Application by Briffa Phillips Architects

DESIGN AND ACCESS STATEMENT AND PLANNING STATEMENT

- 1.1 Planning application: Conversion of Node Court to 8no. dwellings. Conversion of Midden building to residential use and construction of 6no. terraced dwelling-houses.

PROJECT: NODE COURT, DRIVERS END LANE, CODICOTE,
HITCHIN, HERTFORDSHIRE, SG4 8TR DATE: FEBRUARY 2025

New cottages - Proposed Front and Rear Elevations

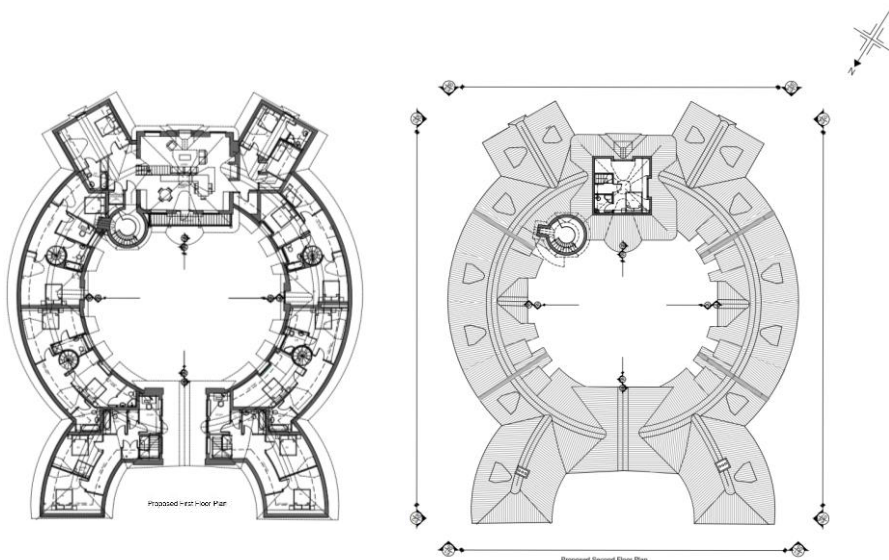
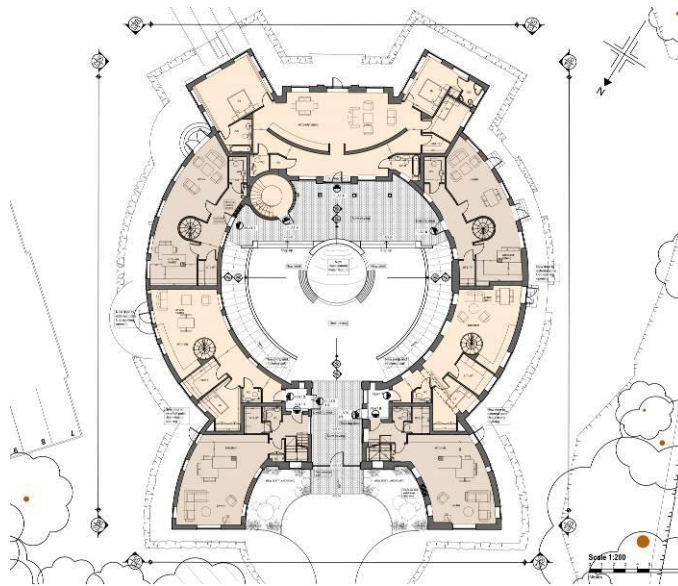
1. *Building Conservation Comment: 'the Heritage Consultant considers that the lack of chimney stacks may appear 'incongruous''.*
Action: A functioning fireplace and chimney stack added to each dwelling, as shown in the amended plans and elevations.

2. *Building Conservation Comment: 'number of roof lights and ground floor windows could appear 'crowded''.*
Action: Roof lights reduced in quantity from 3 to 2; Ground floor windows reduced in quantity and updated to better respond to the proportions of the dwelling, as shown in the amended elevations.

3. *Building Conservation Comment: 'I suggest that the entrances could be improved by extruding the porches'.*
Action: Plans and elevations updated to integrate a front porch at the entrance of each dwelling.

4. *Building Conservation Comment: 'introducing solid 'plank' or 'flush-panel' door type or even a door type to match that shown at Plate 3 of the submitted HBIA'.*
Action: Front door design changed to a solid plank door type with a small window that corresponds with the proportions of the dwelling, as shown in the amended elevations.

5. *Building Conservation Comment: 'omitting the side lights' (from door).*
Action: Side lights omitted and updated on drawings, as shown in the amended plans and elevations.

6. *Building Conservation Comment: 'I am unwilling to support a truncated ridge detail with bargeboards that further serve to emphasise the truncated design.'*
Action: Barge board detail omitted from the design; gables are now complemented by a parapet wall, as shown in the amended elevations. In addition, gables no longer have a truncated ridge, rather a 30 degree pitch with a ridge.

7. *Building Conservation Comment: 'I find both the height of the through-eaves gable forms on the rear and the visually 'heavy' design of the glazing to also be detracting features'.*

1. *Building Conservation Comment: 'I am of the view that modest through-eaves dormers perhaps even with 3-over-3 sashes and with increased articulation of the gables to these dormers can be encouraged.'*

2. *Building Conservation Comment: 'The elevation drawing makes no reference to materials but with the main roof pitch set at 30 degrees this would not be conducive to handmade clay tile. I assume this would be natural slate or perhaps machine-made clay tile? The latter would need to be considered carefully. There is also no indication as to whether the walls would be facing buff or red brick or painted brickwork to echo that of the Dairy?'*

Action: The through-eaves gable omitted and changed to a far smaller dormer window design, as shown in the amended plans and elevations. The glazing has been redesigned to be appear much lighter and more discrete in relation to the proportions of the dwellings.

Action: Dormers updated to a through-eaves dormer with 3-over-3 sashes and a steeper 40-degree roof pitch, as shown in amended elevations.

Action: The elevations of the cottages have been updated to specify the following materials: Natural Slate Roof, Multi Stock Brick and Painted Timber Doors and Windows, as shown in amended elevations.

Images show the proposed elevations of the main building with materials:

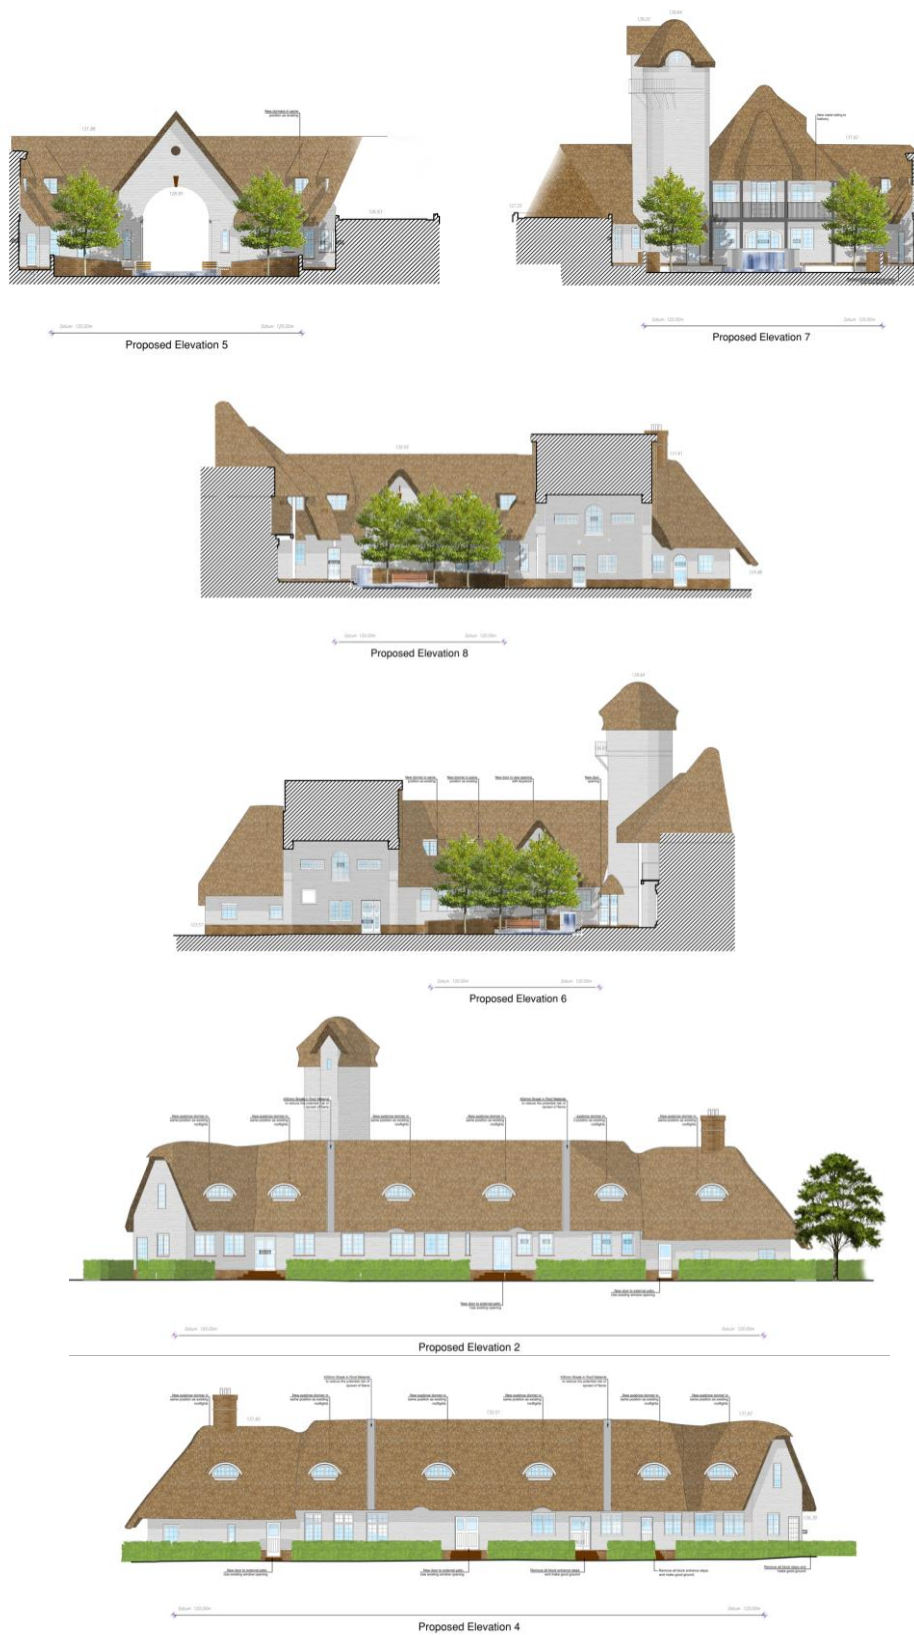
1. *Building Conservation Comment: 'If Node Court is effectively treated as a 'circular' terrace, this provides the means for spread of flame as has previously occurred at this building. To address this and as I have suggested previously, a break in roof material from thatch to perhaps tile at 6 and 12 o'clock would potentially reduce the potential risk of spread of flame.'*

Action: The Dairy design has been updated to include four 450mm breaks in the roof material of The Dairy from thatch to tile, positioned at regular intervals, to reduce the potential risk of spread of flame, as shown in the amended elevations and roof plan.
